**Department of Energy**

DOE-0193-06

**TRANSMITTAL OF THE ADDENDUM TO THE CERTIFICATION DESIGN LETTER  
AND CERTIFICATION PROJECT SPECIFIC PLAN FOR AREA 6 GENERAL AREA  
EAST**

Data Groups: 40743\_05-10-2006,40743\_05-15-2006

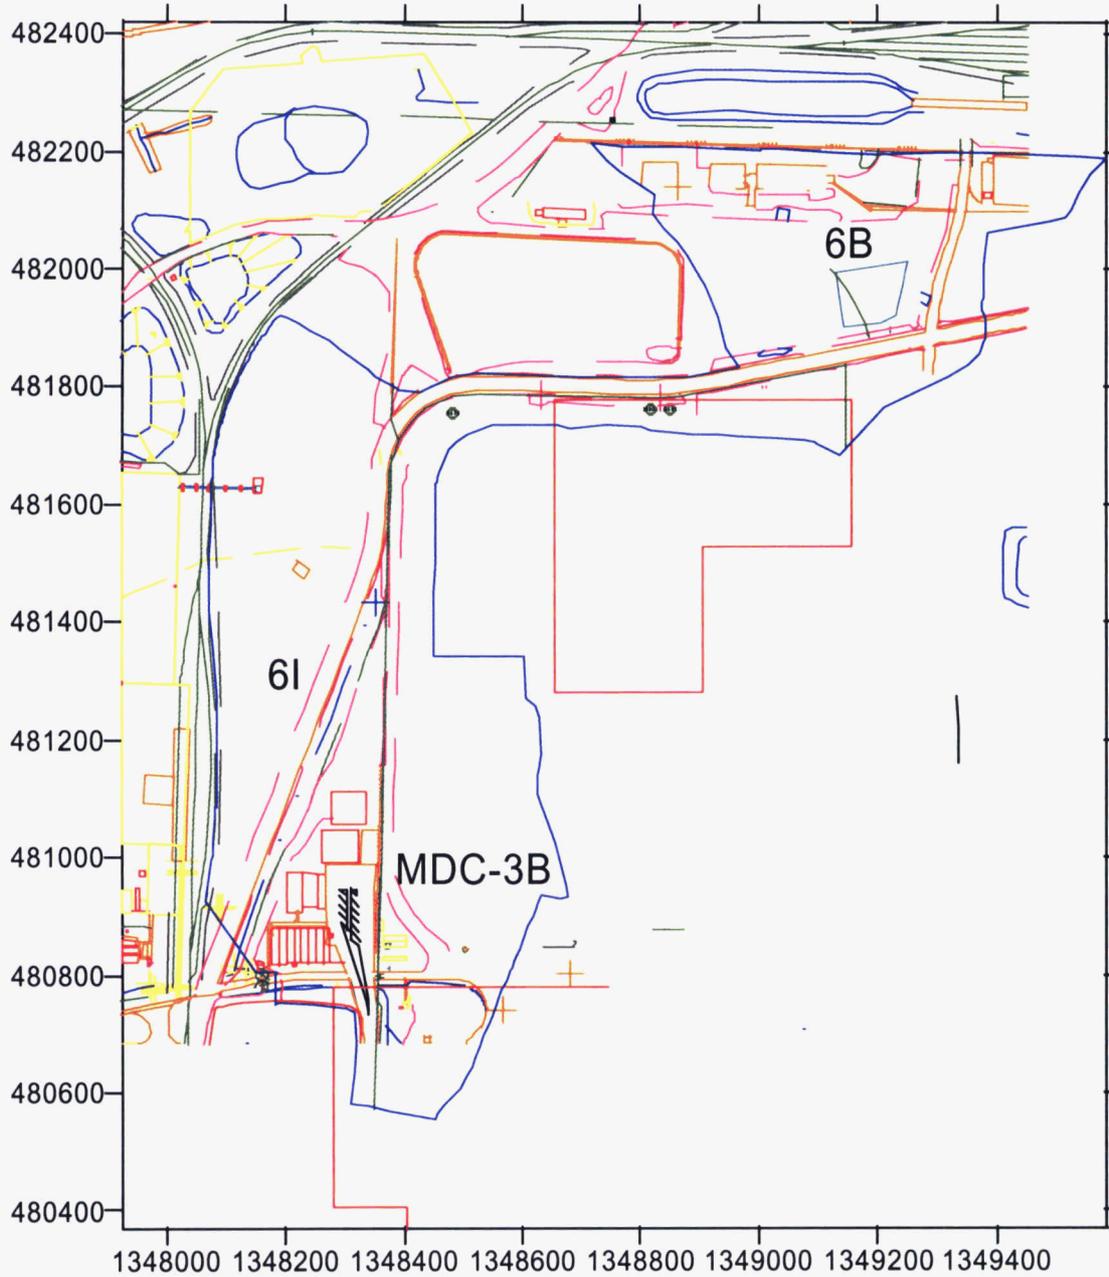
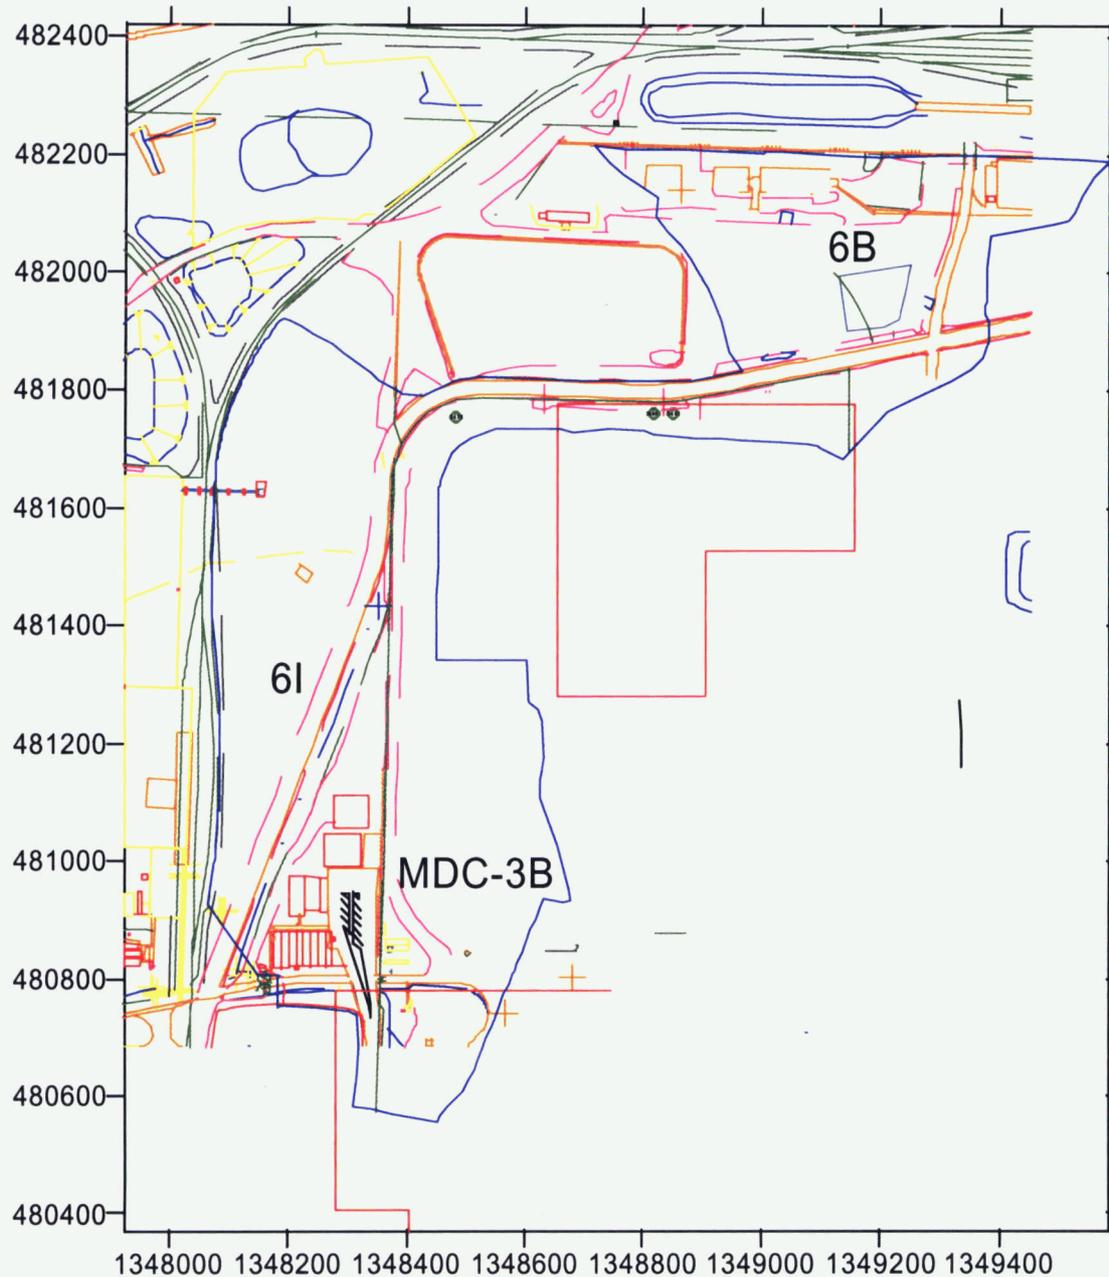
parameters (see Figures 3 through 9) and based on these results, it has been determined that no further remedial actions are required prior to beginning certification activities. The footprint will be restored immediately after the recertification.
